**Visions In Education**  
**TENANT IMPROVEMENT PROJECT**  
**Project # 24-01**  
**ADDENDUM NO. 2**

May 15, 2024

**MECHANICAL  
DEMOLITION  
FIRST FLOOR  
PLAN**

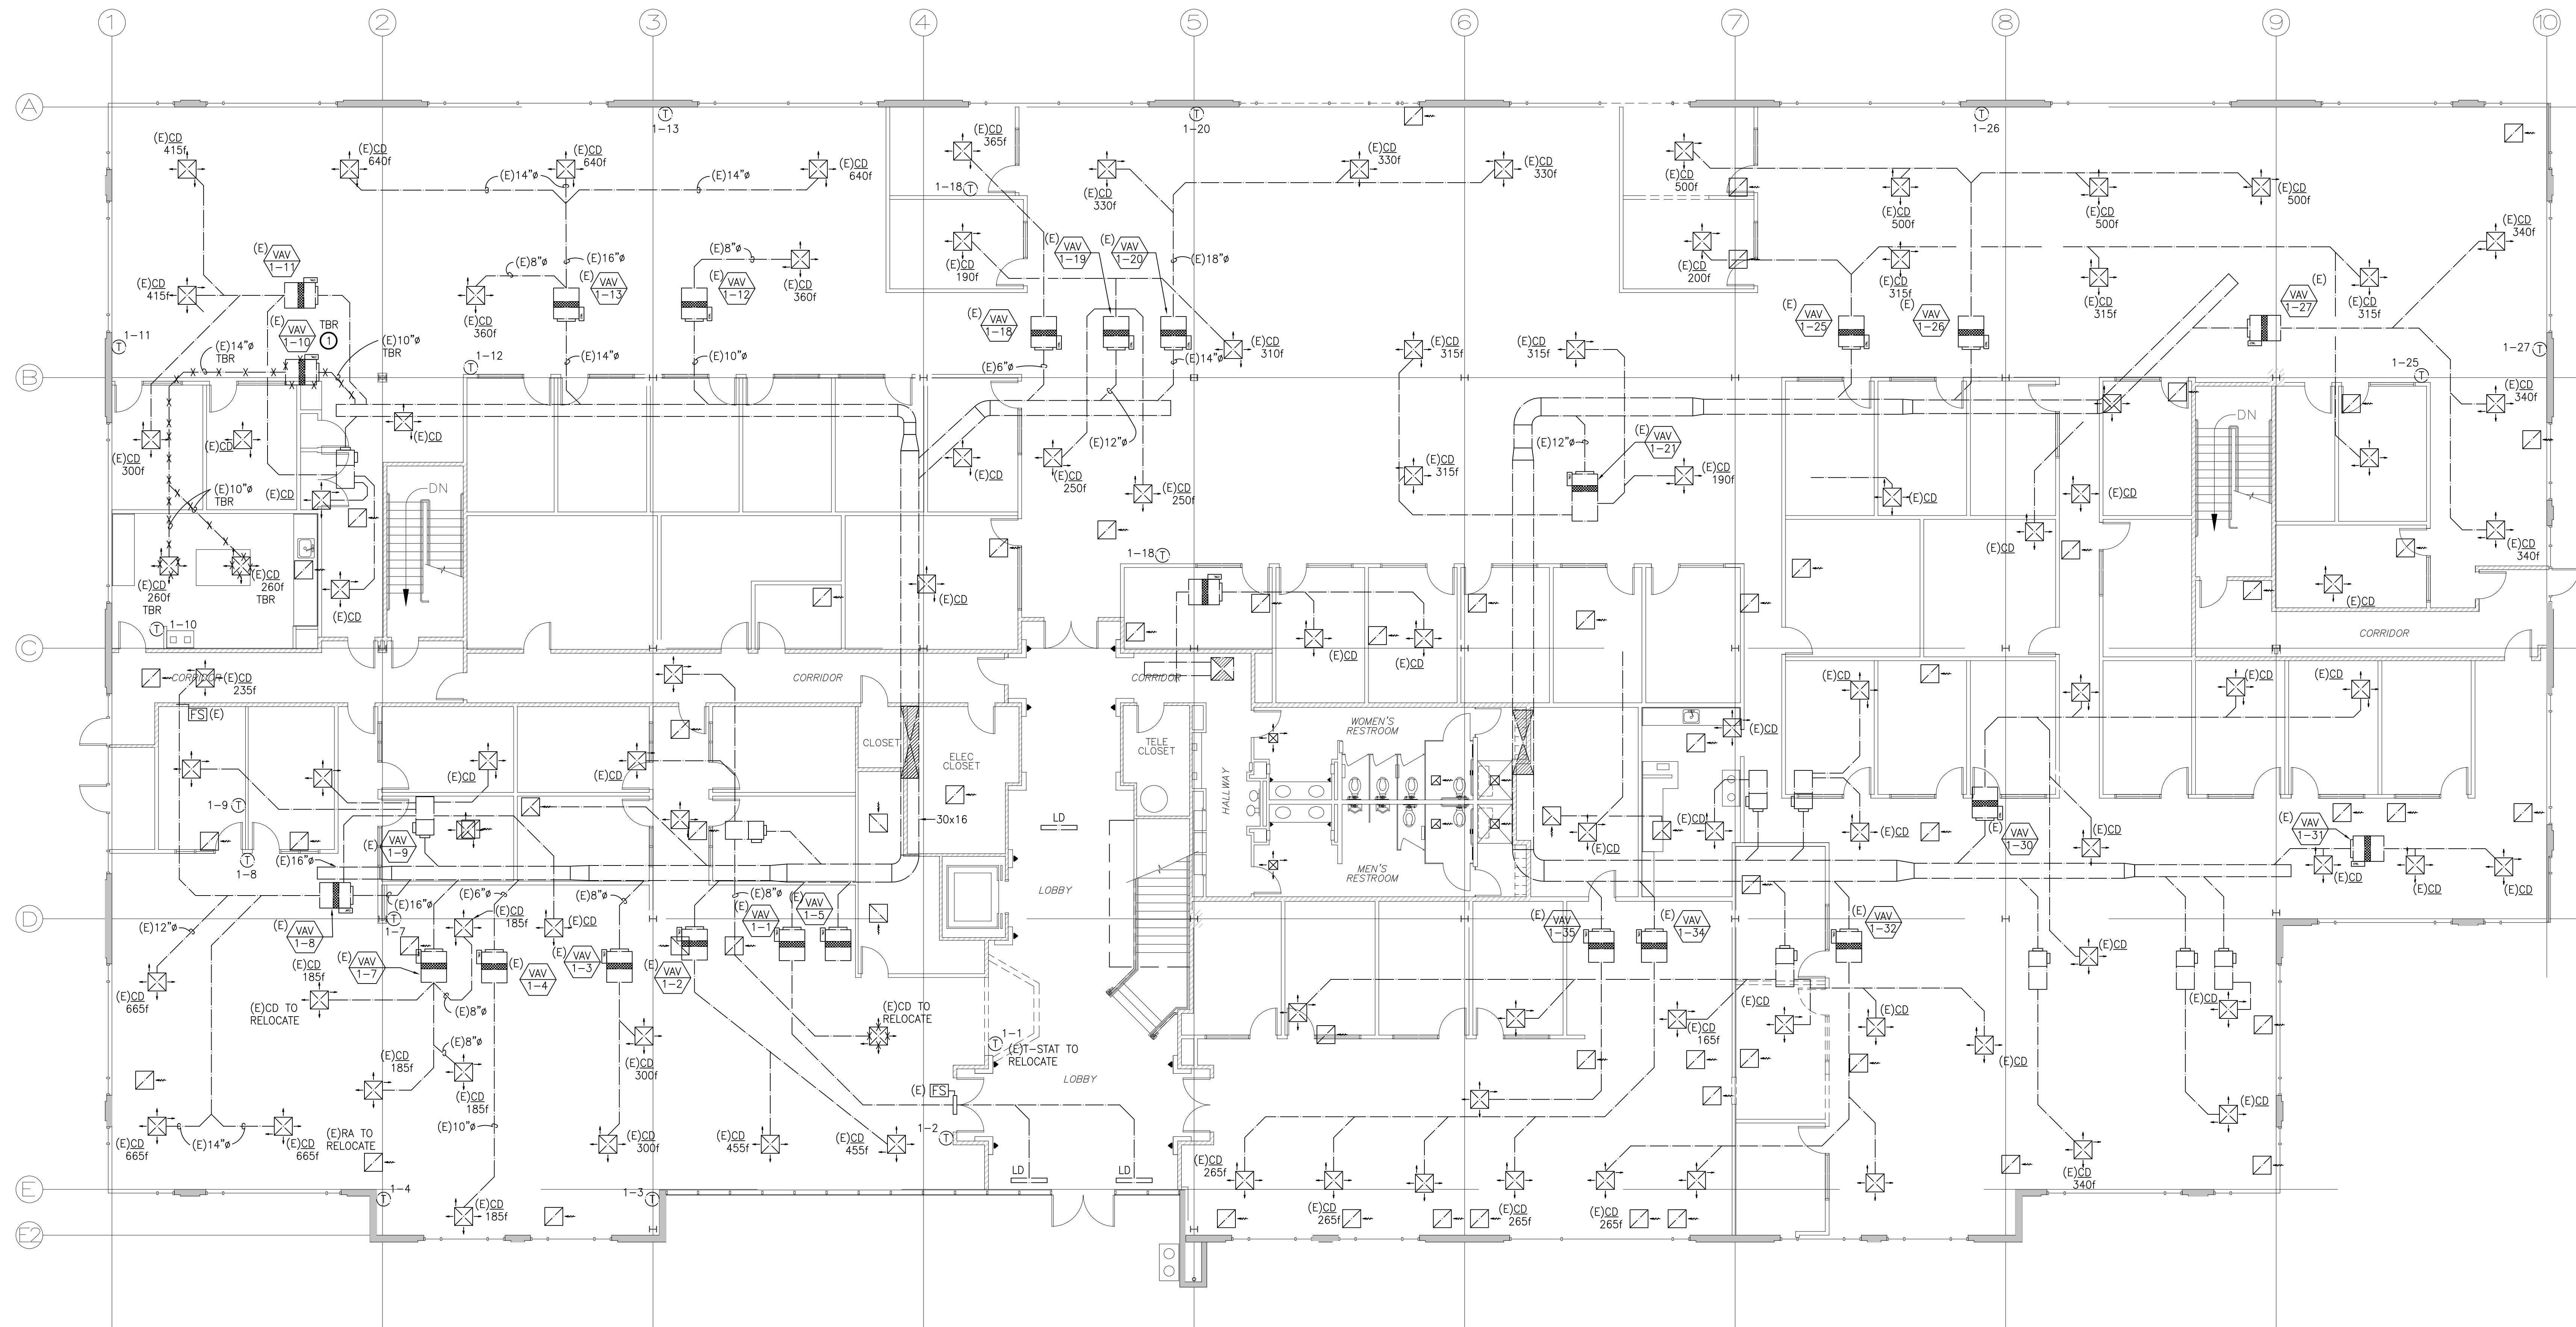
**QUESTION #38:** Drawings Indicate removal and replacement of VAV's 2-6, 2-7 and 2-23. Will the HWS and HWR per detail "D" sheet M3.1 be done by mechanical or the plumbing contractor?

**Response:** The HWS and HWR piping to be installed by the Mechanical Contractor.

PLUMBING  
FIRST FLOOR  
PLANS

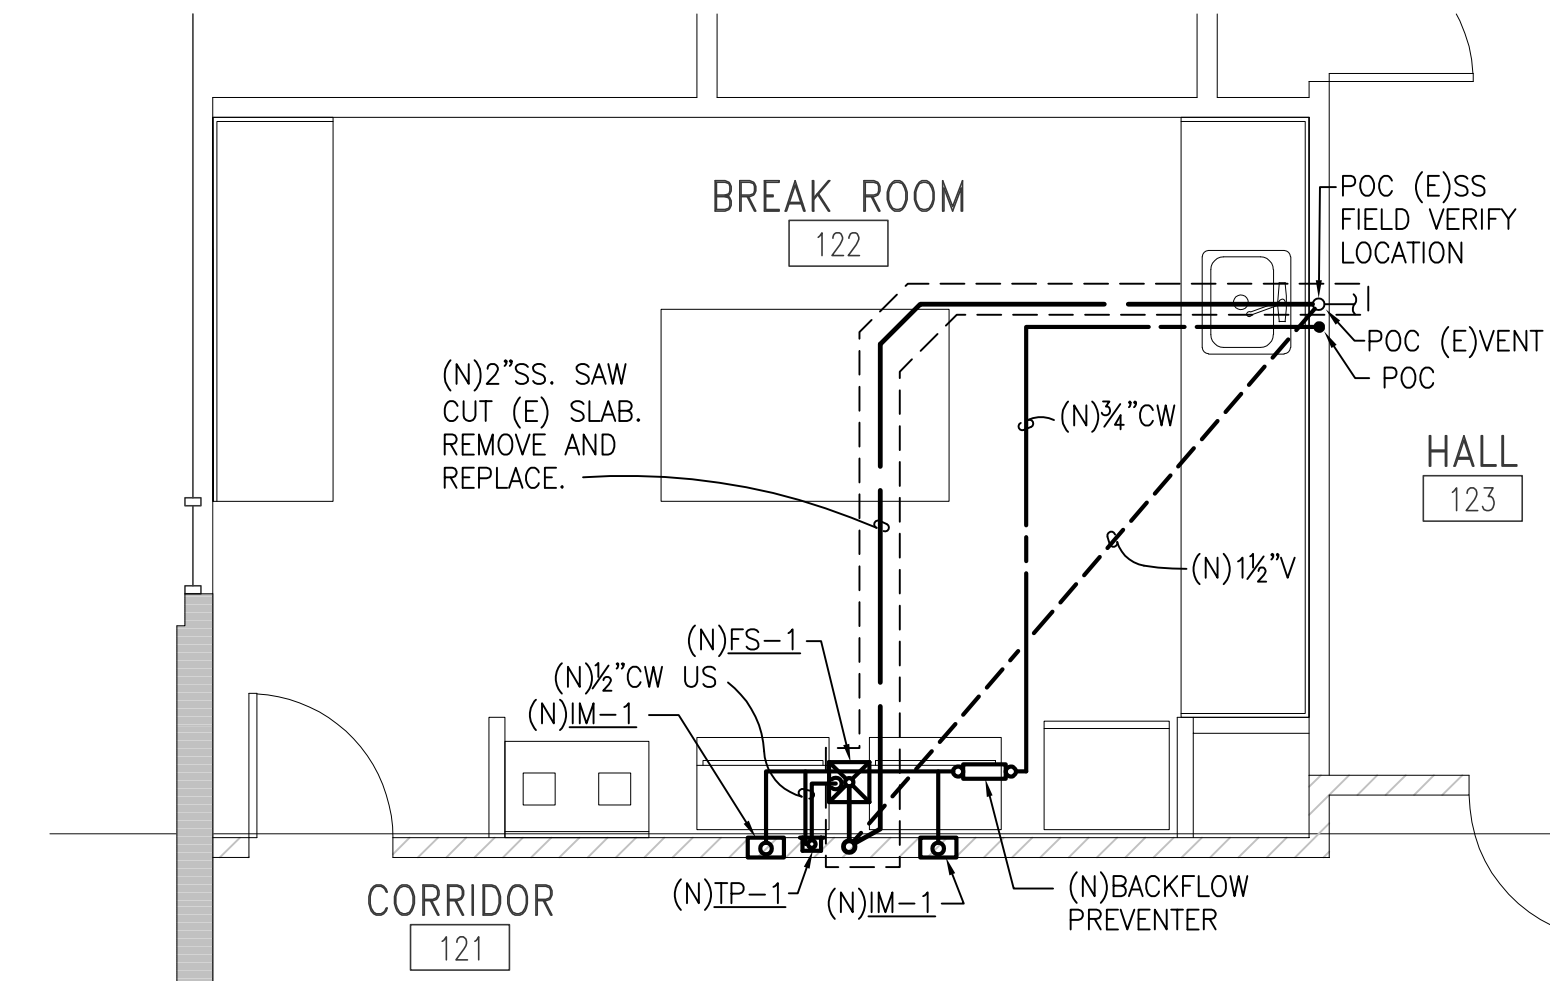
**QUESTION #33:** Plumbing sheets show (2) new recessed water boxes for new ice makers at the 1<sup>st</sup> floor break room. Plan note 22 per A2.1 states the new ice machines are owner furnished and owner installed. If these are ice machines, they will more than likely require a drain. If this is the case, do you want all teams to provide a floor sink in the room?

**QUESTION #36:** Key note #33 indicates (2) ice machines. Can we get the model number of the owner provided machine? Does it require any kind of drain?

**Response:** See sheet P2.1 in this addendum set.

**Response:** Cut sheets are provided in this addendum as Attachment 2.12. See Sheet P2.1 for drain location.
